# NORTHEAST UTILITIES

Millstone Nuclear Power Station, Unit No. 3  
Summary/Submittal of Responses to PSB Electrical Draft SER Items

Status of PSB Electrical SER Items

FIGURE 8.3-8 (SH 1062)  
CABLE TRAY  
CABLE ENTRY/EXIT

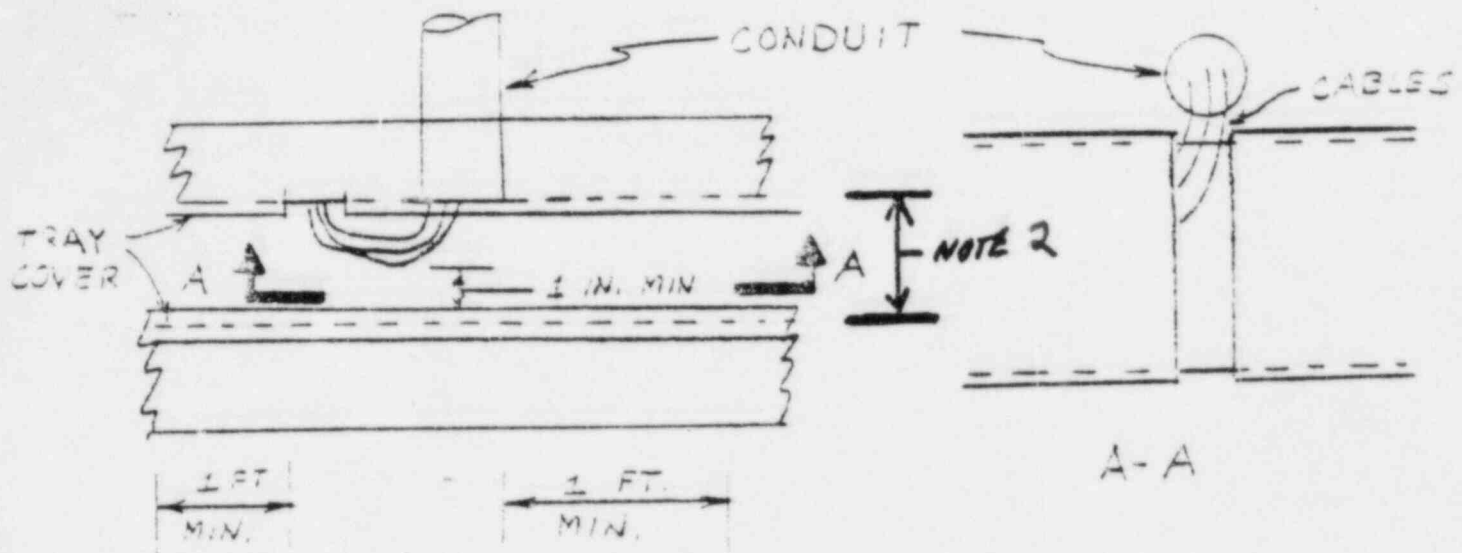
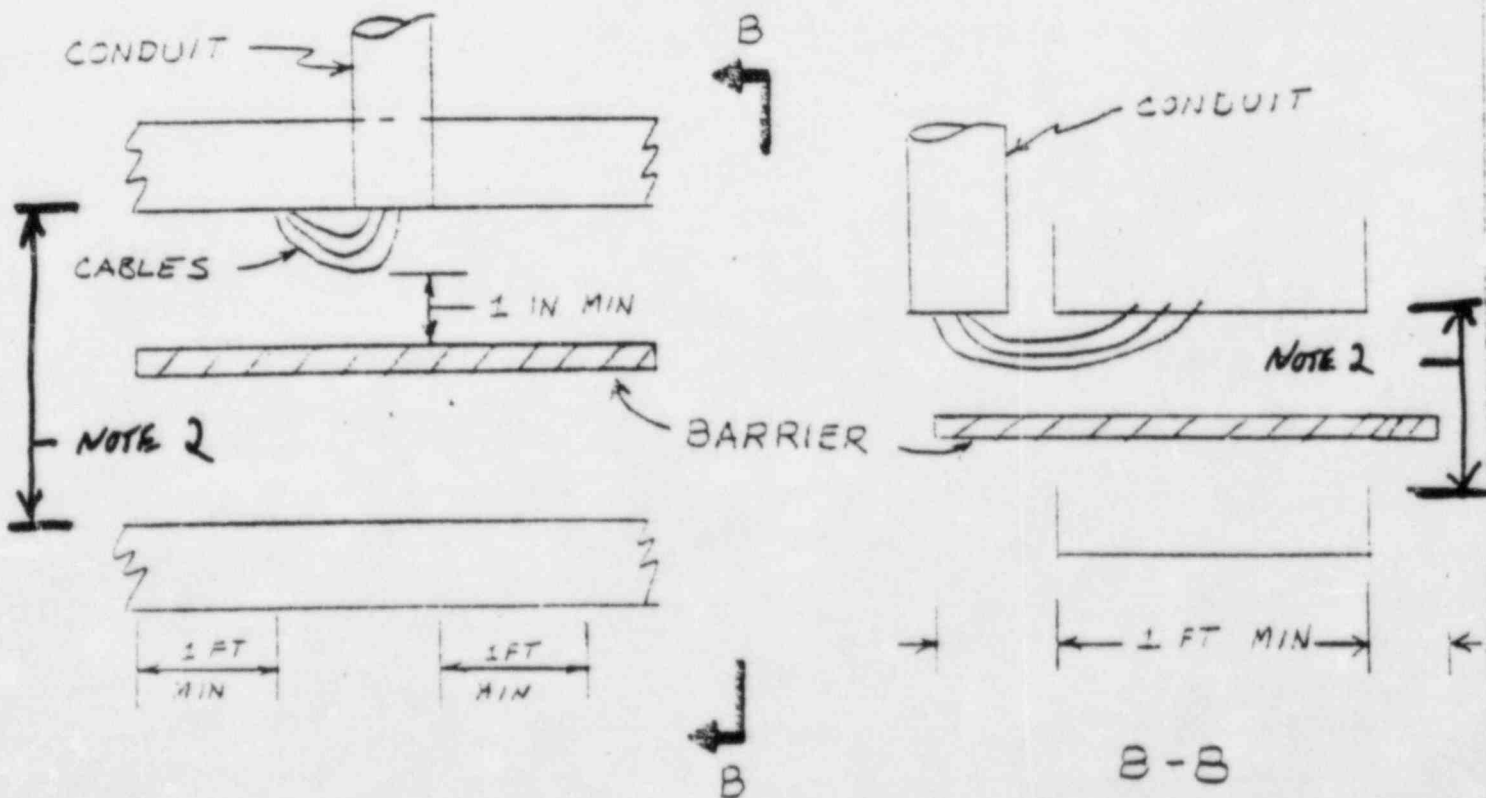
Refer to revised section 1.8, R. G. 1.75 and new Figure 8.3-8.

1. <u>General (Clarification)</u>	1.18 1.19  1.21
		For separation purposes, location of cable entry/exit from cable tray is considered to be equivalent to perpendicular cable tray crossings. Refer to Figure 8.3.8.	1.23 1.24 1.25 1.26
		Ventilated tray covers are considered equivalent to solid tray covers.	1.28 1.29
